Best of September 2021

The following are a dozen questions answered by the NFSA's Codes, Standards, and Public Fire Protection staff as part of the Expert of the Day (EOD) member assistance program during the month of September 2021. This information is being brought forward as the "Best of September 2021." If you have a question for the NFSA EOD submit your question online through the "My EOD" portal.

Question #11 – Sprinklers below “sawtooth” roof

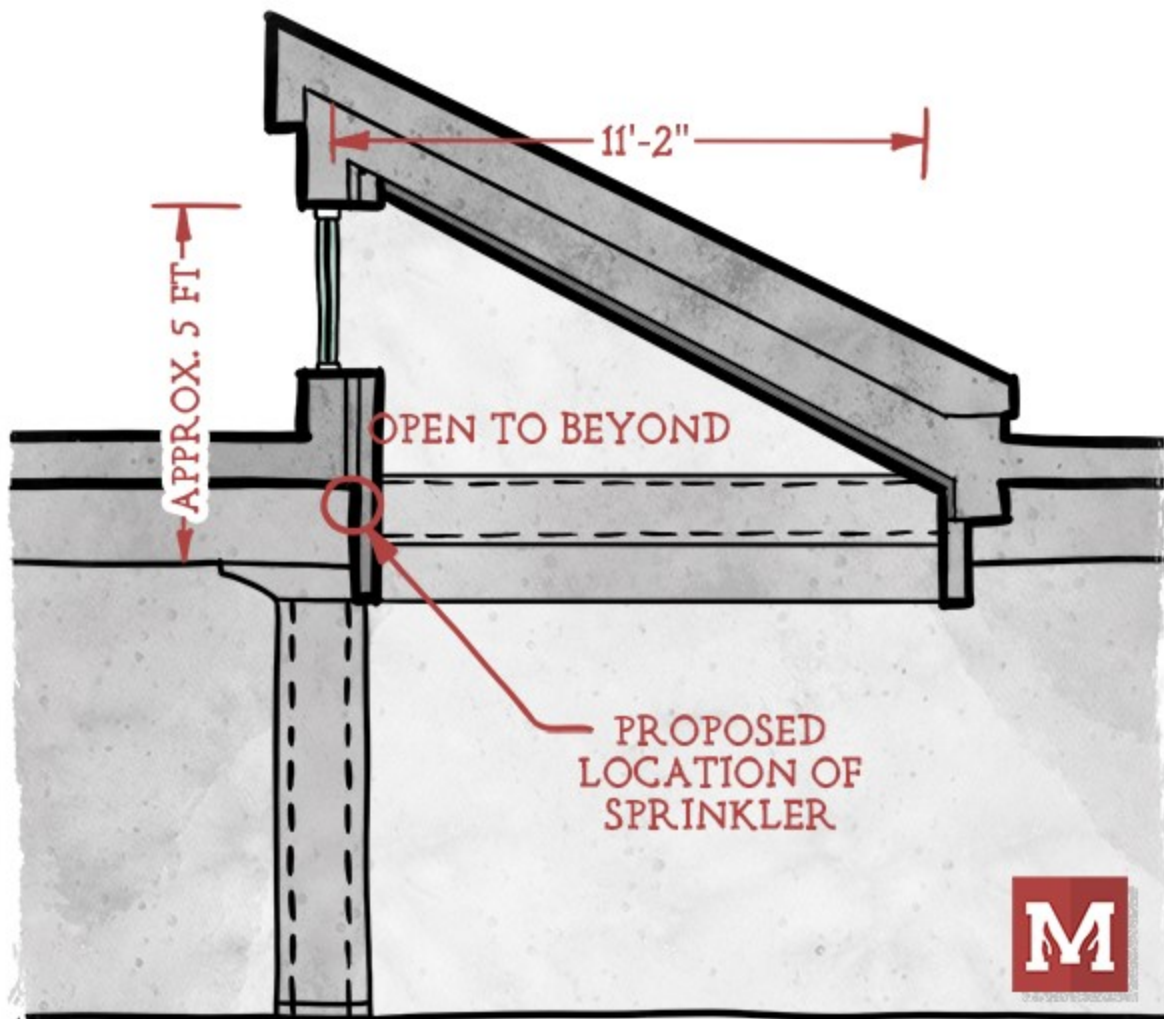
A project includes an area 32 ft x 11 ft with a sawtooth pattern raised ceiling, sort of like a skylight. This ceiling jumps up approximately 5 ft on one side to allow vertical windows and then the ceiling slopes back down to the original 9 ft high ceiling which surrounds this area.

Since this area is over 32 sq ft, it cannot be treated like an unprotected skylight. And since it is over 36 inches tall on one side, it cannot be treated as an unprotected ceiling pocket.

In this scenario, would it be acceptable to have sidewall sprinklers approximately 4 ft-6 in down from the peak, spraying horizontally straight across this ceiling?

No, NFPA 13 does not have a prescriptive method that would permit a sidewall sprinkler to be installed with a deflector distance of 4 ft–6 in below the highpoint of the ceiling. As noted in section 8.7.4.1.1, sidewall sprinklers are to be installed with the deflector located no more than 6 in. below the ceiling (may be up to 18 in. when listed for such use).

Additionally, section 8.7.4.2.1 requires that the deflector be installed parallel to the ceiling. Finally, Section 8.7.4.2.2 states that for sloped ceilings (such as described) the sidewall sprinkler needs to be located at the “highpoint of the slope and positioned to discharge downward along the slope.”

You are correct that the scenario described would not permit the skylight omission (8.5.7) as the area exceeds 32 sq ft or the ceiling pocket omission rule (8.6.7) as the depth of this “pocket” exceeds 36 in.

It appears that this scenario is limited to the following options:

1. Install sprinkler(s) within this “pocket” adhering to the prescribed deflector distances. It should be noted that a pendent or upright sprinkler may be installed up to 36 inches below the high point as noted in Section 8.6.4.1.3.1 or, Section 8.6.4.1.3.2 for saw-toothed roofs.
2. Provide calculations in accordance with Section 8.1.1(6) that will demonstrate that the sprinklers installed with a greater deflector distance than prescribed, will still activate in a timely manner and perform comparable to sprinklers installed in conformance with the rules of NFPA 13.
